June 2001

DEFENSE ACQUISITION

Comanche Program Objectives Need to Be Revised to More Achievable Levels

GAO-01-450

Figure 1: Comparison of Comanche Pre-Production Aircraft Deliveries

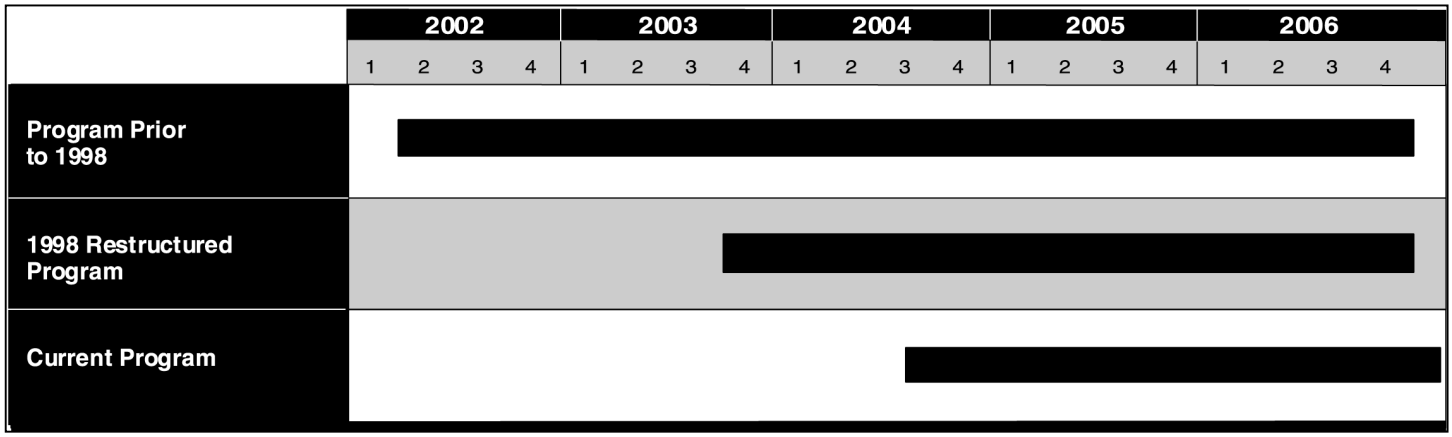
Since our last report, the first pre-production aircraft to be used for development testing is now scheduled for delivery in January 2004, adding an additional 3-month delay to the 19-month delay we reported in August 1999. As shown in figure 1 below, the delivery of pre-production Comanche aircraft has been delayed and, because the Army has retained the December 2006 full-rate production decision, the time available for testing, assessing, and correcting problems has been reduced.

Figure 2: Comanche Concurrent Flight Testing and Production

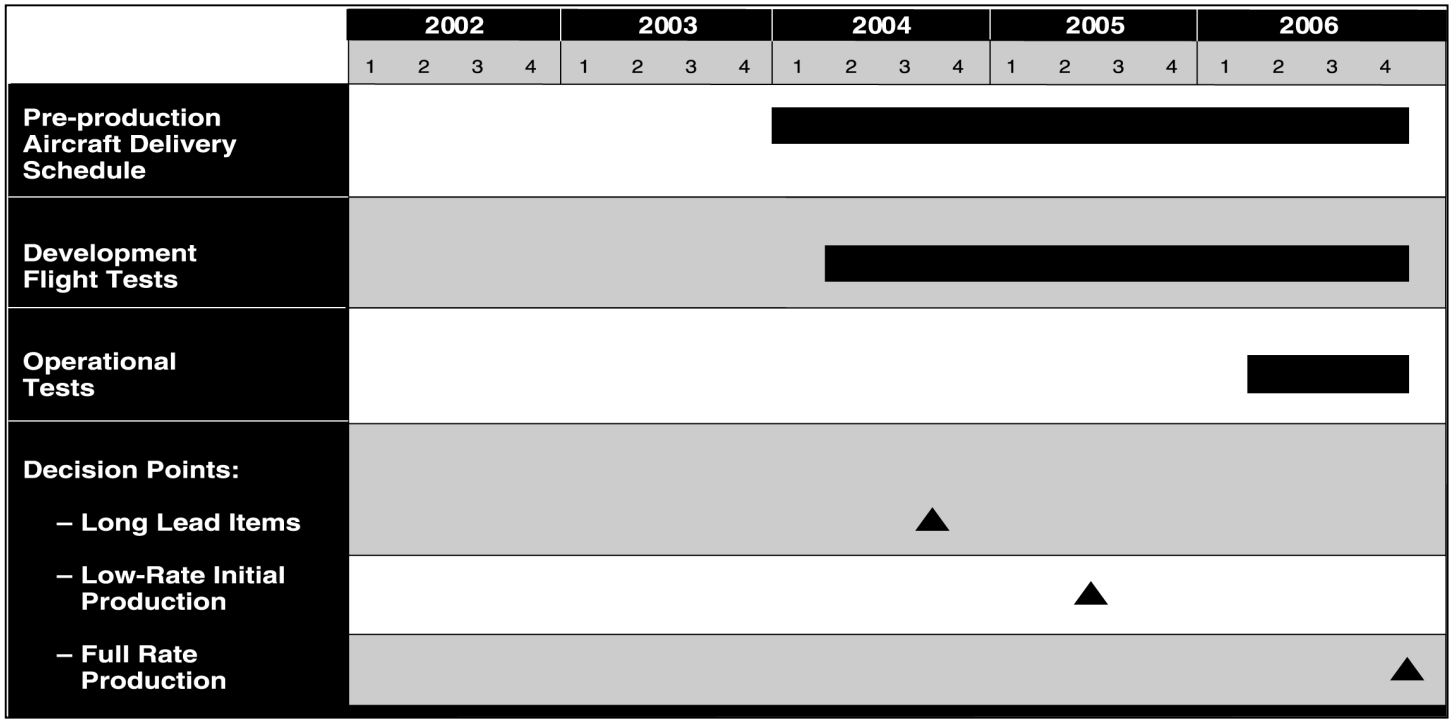
Many critical test events are now scheduled late in the development stages—during the low-rate initial production phase of the program—and, as shown in figure 2, many developmental and operational test events are scheduled to be conducted concurrently.

The combination of compressing the development schedule and undertaking developmental and operational testing activities concurrently leaves the Army with little room to accommodate any delays that may result from assessing, correcting, and retesting problems found during testing. In Comanche's case, several critical subsystems—to be included in the mission equipment package—may not be available until the development flight-testing is well underway. These subsystems are very complex, state-of-the-art systems that have not been demonstrated on a helicopter platform like Comanche. As testing proceeds, any problems found will need to be analyzed, fixed, and retested. However, with the ambitious test schedule, there may not be time available between test events to correct problems and prepare properly for the next event.
